Sportster and Buell XB Model Flywheel Sprocket Shaft Nut Torque Update

1. Sprocket Locking Link (Part No. HD-46283 or HD-38362)
2. Shifter Shaft

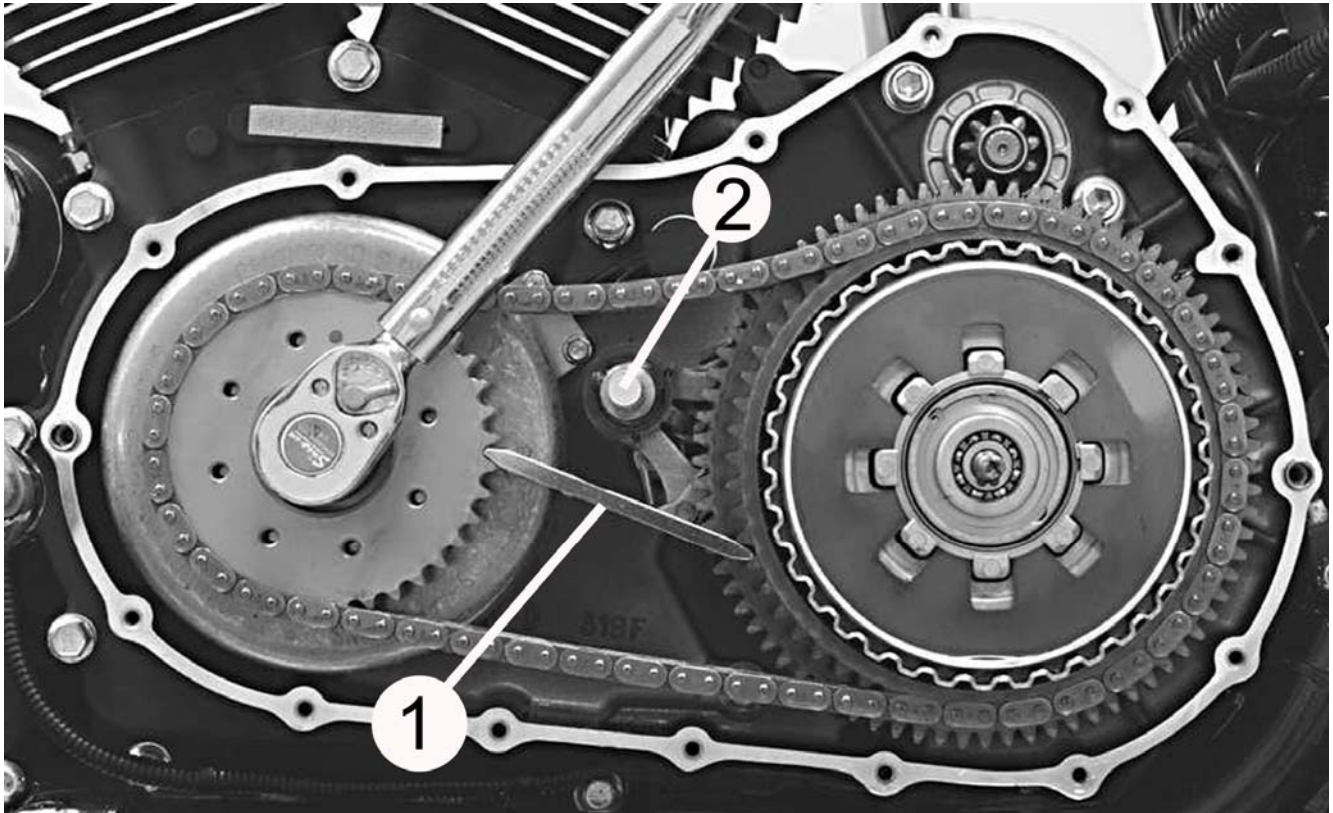
The flywheel sprocket shaft nut torque for 2004 & later Sportsters and 2003 & later Buell XB models has been changed. The torque has been **increased** from 190-210 to **240-260 ft lbs**. Remember to clean the threads and generously apply LOCTITE Threadlocker 262 (red) onto the threads of engine sprocket shaft and use the SPROCKET LOCKING LINK (Part No. HD-46283 or HD-38362) as shown in the picture below.
